Public Comments

Subject: 80 Clear Creek Road Viewshed Protection Program P22-00182-VIEW, Initial Study/Mitigated Negative Declaration, SCH No. 2025091008, Napa County

Re: 80 Clear Creek Road, Napa, Viewshed Protection Program Application P22-00182-VIEW (the "Application")

TENNIS PAVILION (TP) - NORTHEAST VIEW

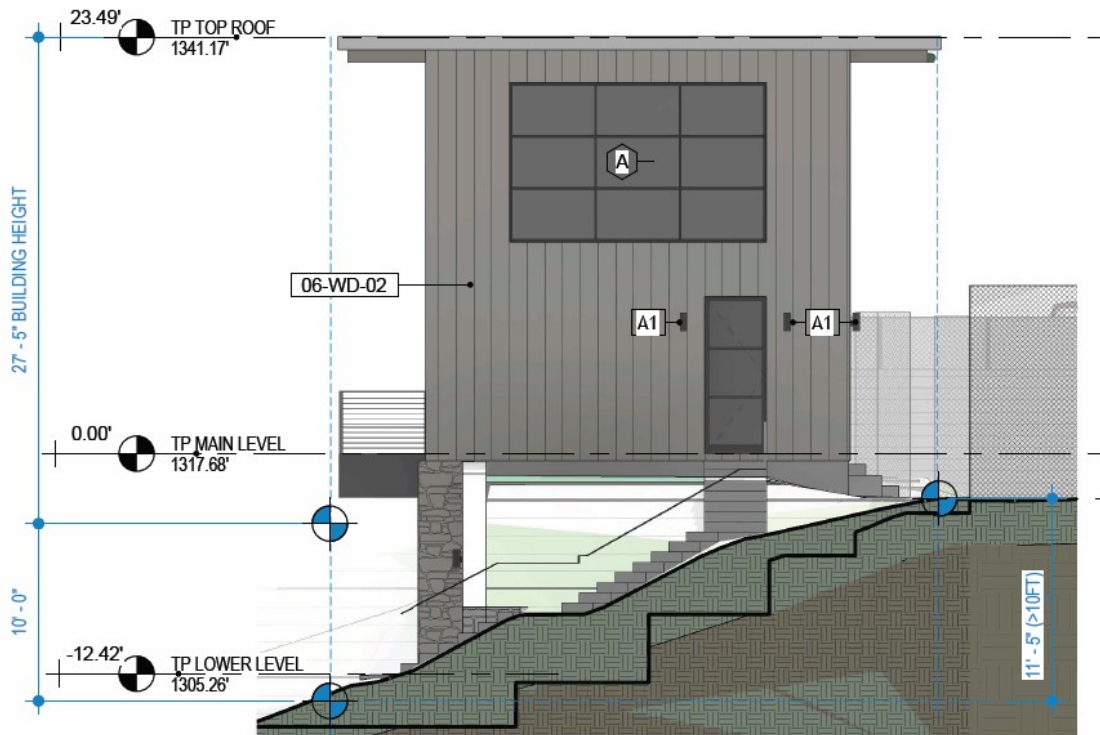
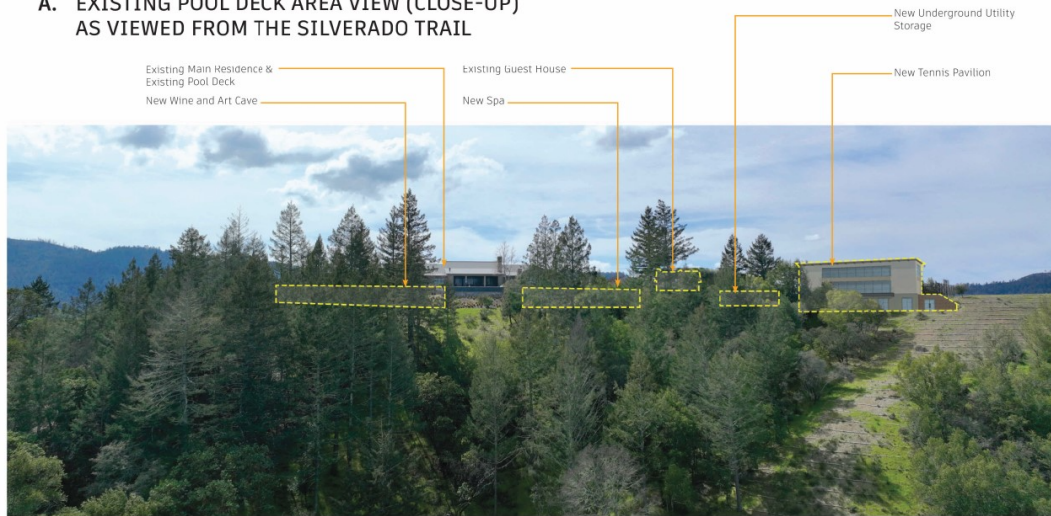
As seen in the images following this letter (excerpted from the Application), the proposed project falls short on many of the design requirements set forth in the Viewshed Protection Design Manual, particularly section 2 (design, height and massing of hillside development). The tennis pavilion is a massive three-story rectangle – it is 82' x 34' and approximately 37' feet tall from lowest grade (possibly exceeding the maximum 35' height (see Napa County Code 18.104.010 table of zoning district regulations) – it contains 6,240 square feet (2/3 the amount of space in the main residence) – the face is covered with a significant amount of glass and metal, and the roof line is lighted, both of which will enhance its negative visual impact.

Here are just a few of the tennis pavilion's departures from the design principles intended to protect the natural beauty of the Valley:

- No balance of scale and proportion
- Design elements are not harmonious with natural landforms (there are no giant rectangle boxes in nature)
- Not small scale or low in height
- Does not conform to hillside topography by stepping or staggering mass up or down the slope
- Predominate feature is flat vertical massing with a lighted roofline
- No articulation to break up the scale and mass of the building
- Protrudes above ridgeline, highly visible from surrounding roads, including major public roads
- Does not minimize lighting, maximizes it for convenience of tennis players
- Height may exceed 35' maximum
- Uses vertical massing and stacking instead of integrating the structure with the slope
- Roof not sloped, diverges sharply from natural slope, does not follow the gradient

Additionally, screening of the tennis pavilion is highly inadequate (see graphics A004-00, A005-00, landscape site plan LA1 and LA2). The viewshed vegetative screening letter proposes 10-gallon replacement trees, which are young saplings 4-6 feet tall. For these to reach a mature height of 50 feet will take 30 to 50 years (according to ChatGPT). Effectively, there will be no screening for decades at best.
